WATER QUALITY MEMORANDUM

Utah Coal Regulatory Program

RE: 2010 3rd Quarter Water Monitoring, Genwal Resources, Inc., Crandall Canyon Mine, Permit & Tracking #3625

Total Iron (T-Fe): Outfall 002

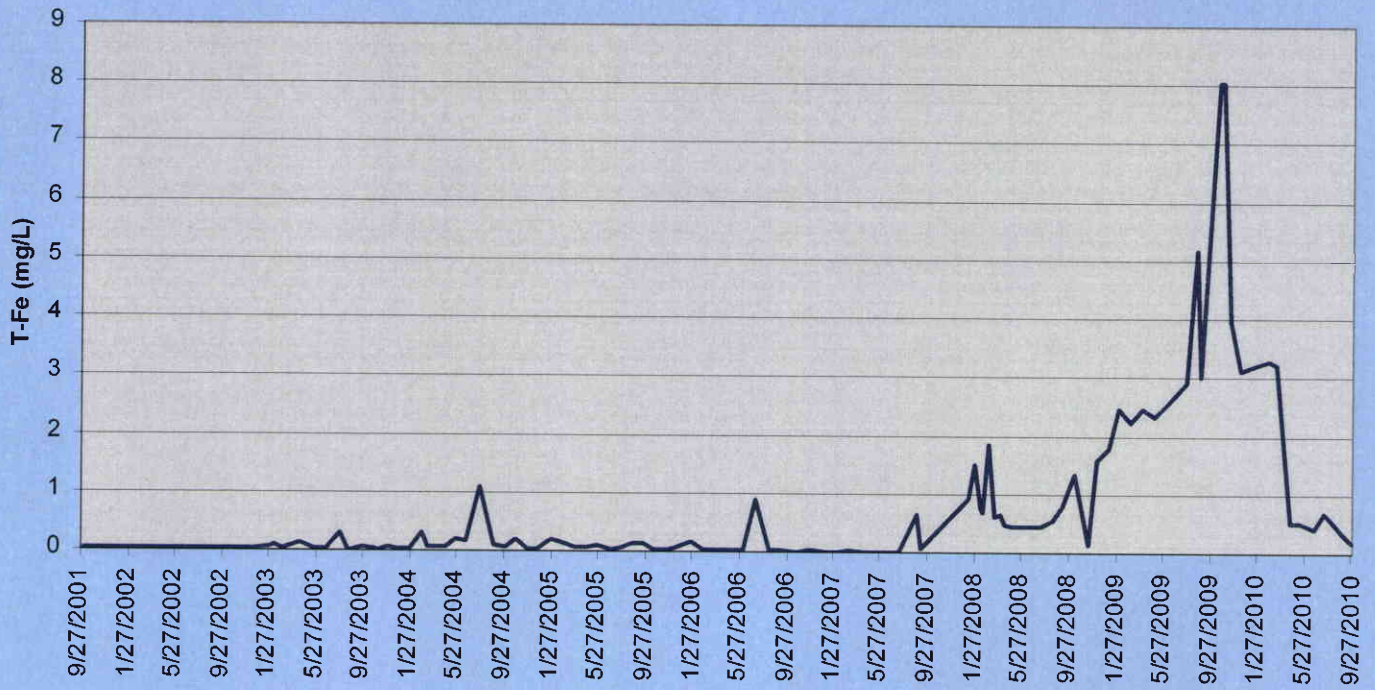
Based upon three sampling events, outfall 002 reported an average flow value of 516 gpm. The T-Fe concentrations of the water discharging from the mine-water treatment basin were well within the 1.0 ppm standard established by the UPDES permit (0.17 ppm, 0.39 ppm and 0.68 ppm for July, August and September respectively). The mine-water treatment system continues to be effective in reducing the T-Fe concentrations.

Spring SP-58 Water Quality

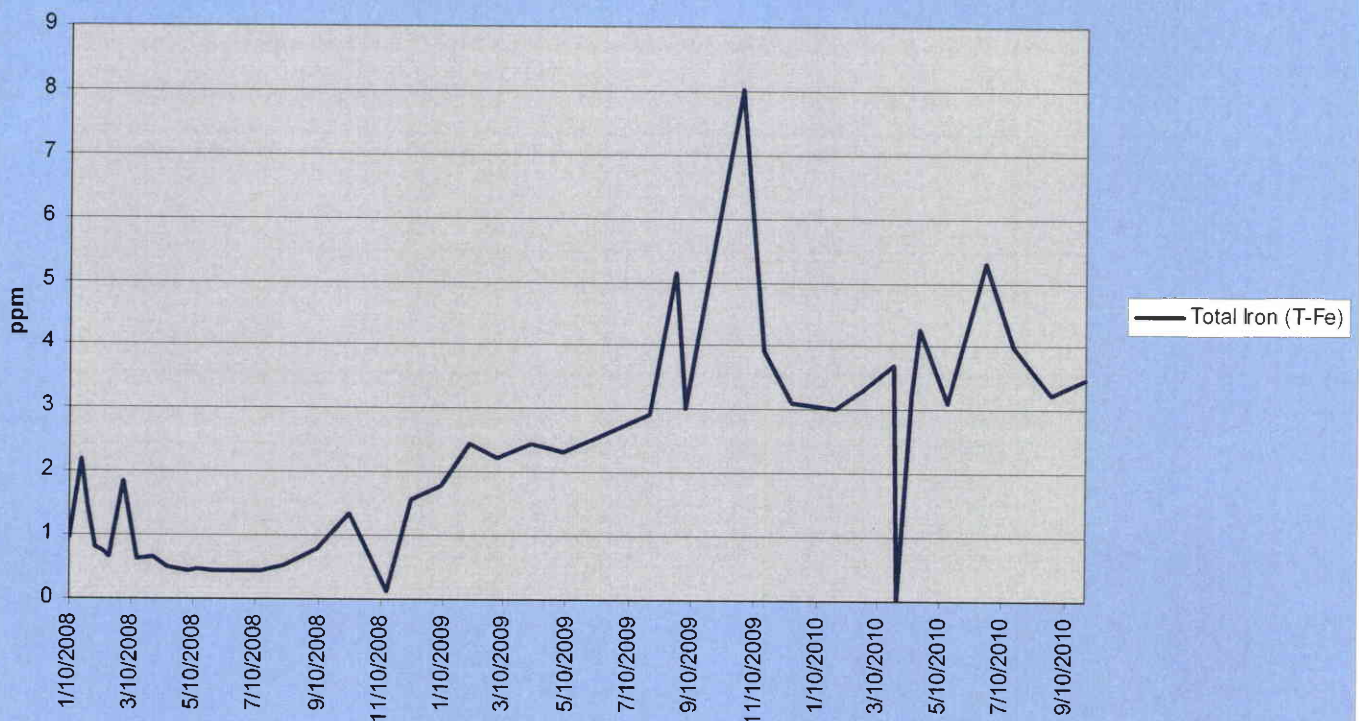
SP-58 reported elevated TDS and SO4 for a second consecutive quarter. The site was inaccessible the 1st quarter of 2010; however, elevated D-Ca was reported during the 4th quarter of 2009.

Spring SP1-33

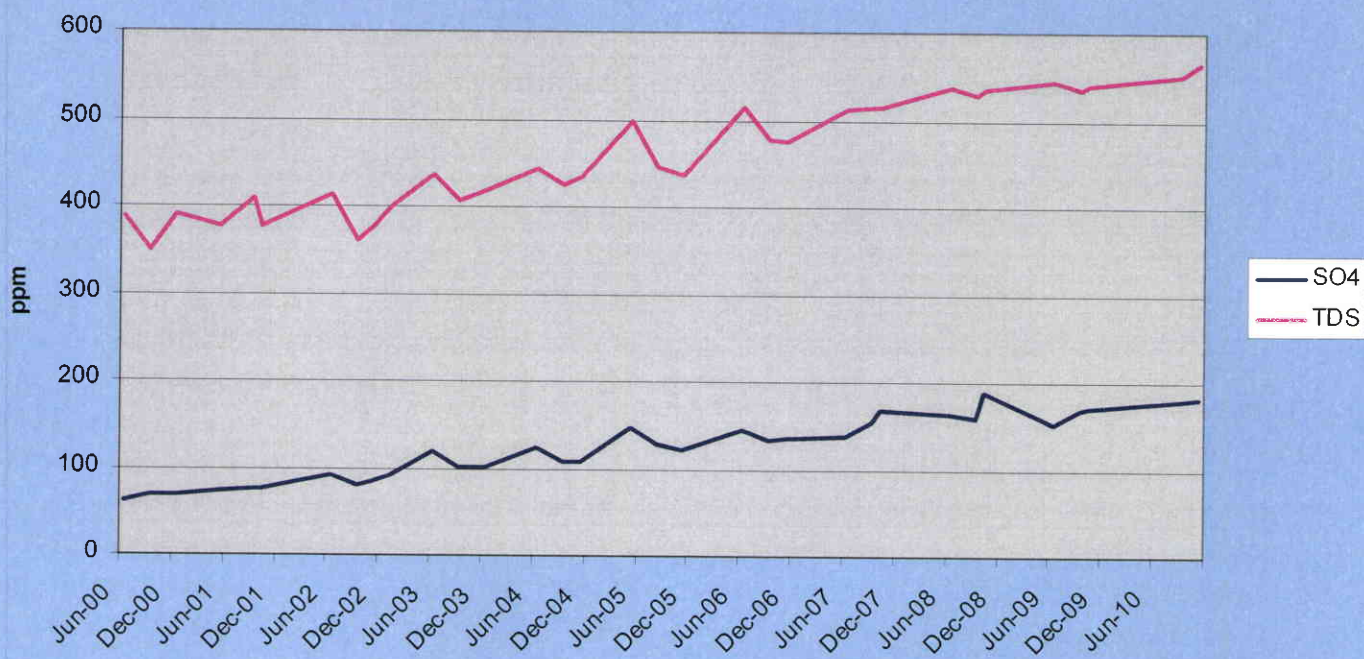
SP1-33 reported an elevated concentration of SO4 for the second consecutive quarter.
